Brescia, 15th July 2015

PHASE OUT PRODUCTS	E506 / E509
NEW PRODUCTS	E525

NEW E 525 VERSION

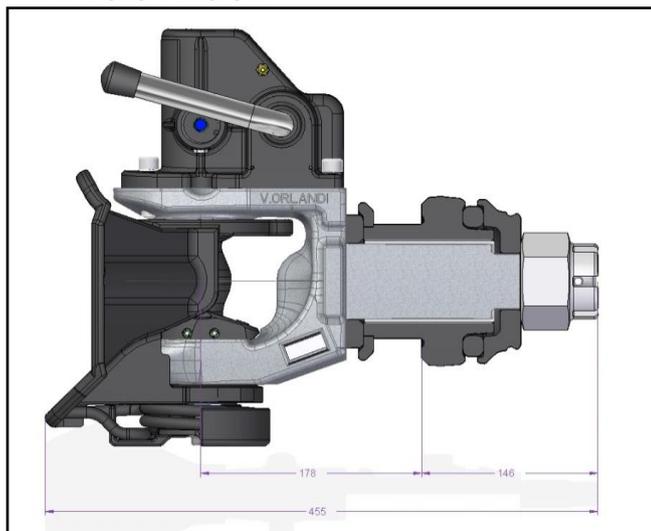
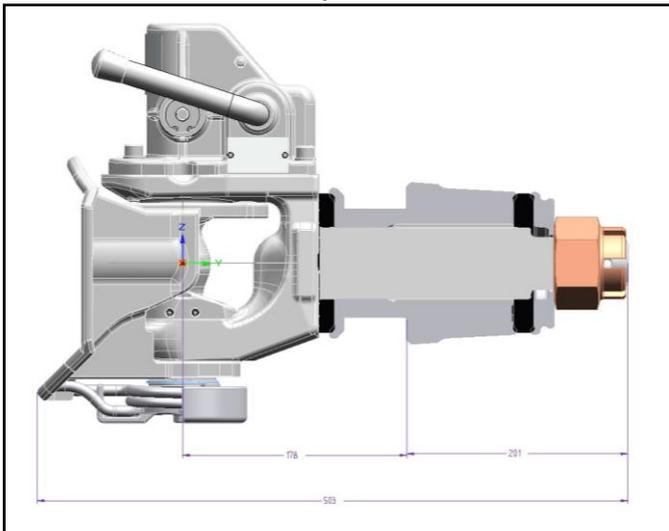
Compared to the previous E506 and E509, the new E525 has the following characteristics:

1. **SHORTER:** the overall length is 455mm instead of 503mm
2. **LIGHTER:** the overall weight is now **ONLY 42 kg** (previous E506 and E509 were 48 kg)
3. Most of the E506/E509 **SPARE PARTS** are **INTERCHANGEABLE** except:
 - **NEW** nut cover (**RG00603**) which is now rigid, easier to be mounted (old part number RG00034)
 - **NEW** flange (**RG00617**) which has been redesigned (old part numbers: RG00583 for E506, RG00352 for E509)
 - **NEW** rubbers (**RG00618**) which have been redesigned (old part number RG00184)
